## REQUEST FOR PROPOSALS ADDENDUM #1

**Proposal Number:** RFP 22-015

**Proposal Title:** Phase 2 Recycled Water East Reservoir

Soil Disposal Area

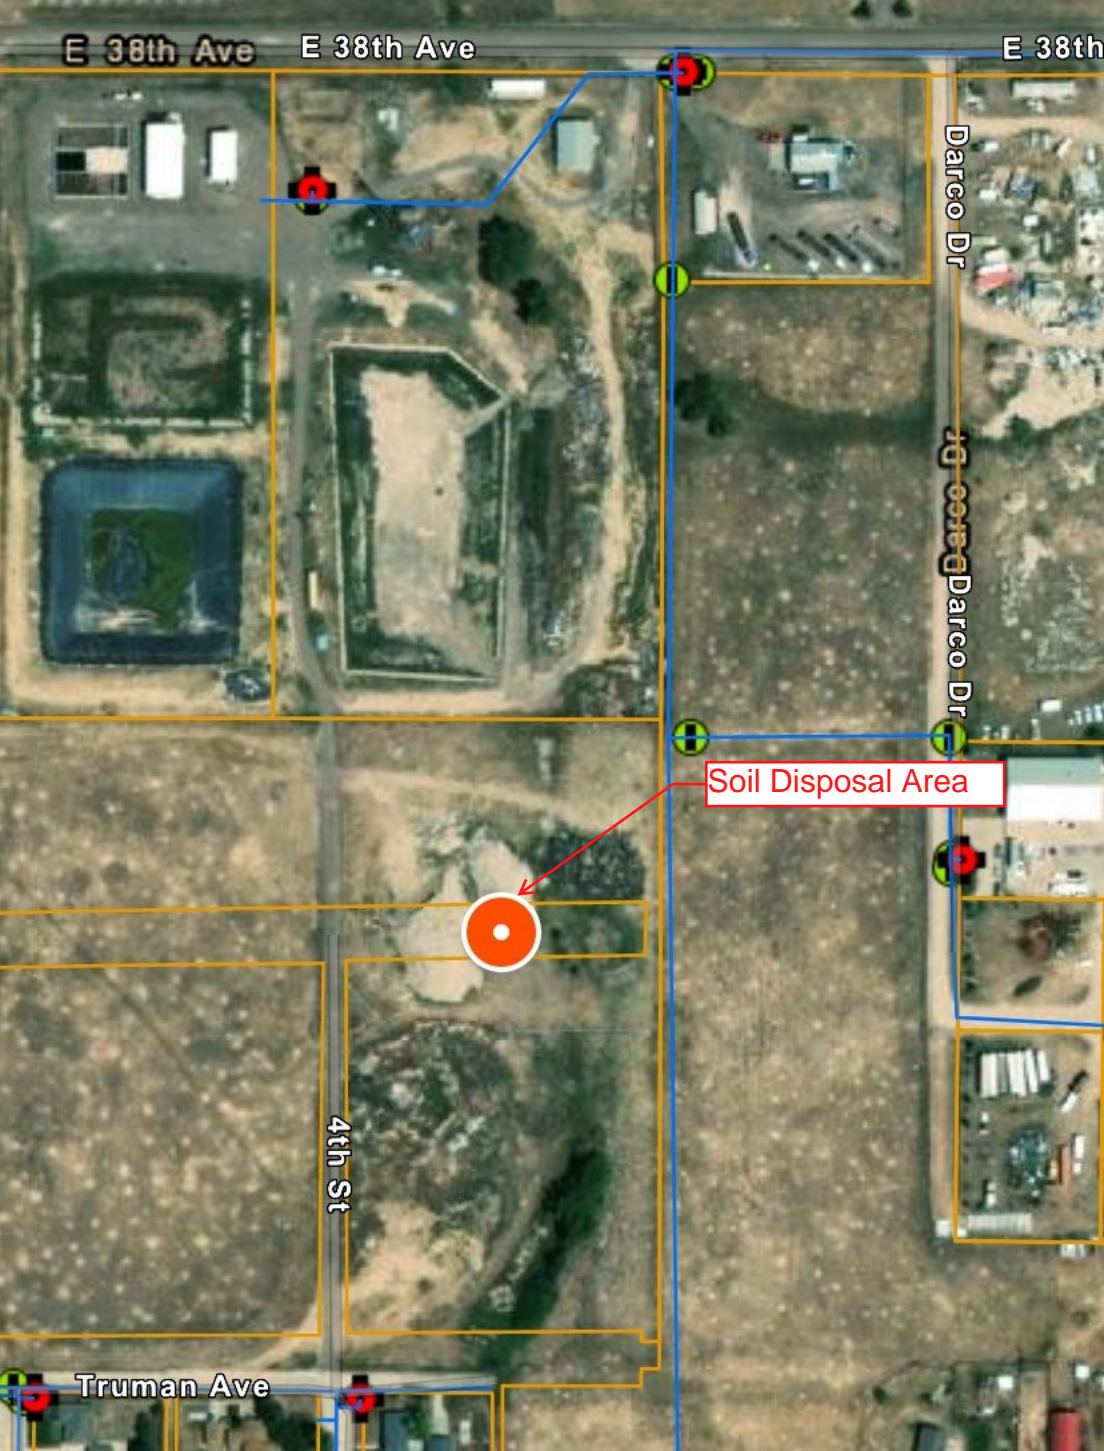
1. Please clarify whether the contractor needs to move the existing construction debris south of the reservoir, prior to placing the excavated spoils.

15. Can you highlight the stockpile location on the project map? Are there any restrictions on the haul route?

*The remaining excess soil, after grading work is complete, shall be hauled to the soil disposal area south of the project site as shown on the attached map. Debris that needs to be disposed of shall be hauled offsite by the contractor. The timing of these activities shall be determined by the contractor.*

The soil disposal area is immediately south of the project area (see attached map). There are no limitations on the haul route other than to protect existing structures, provide access to any existing buried valves, and to restore after construction.
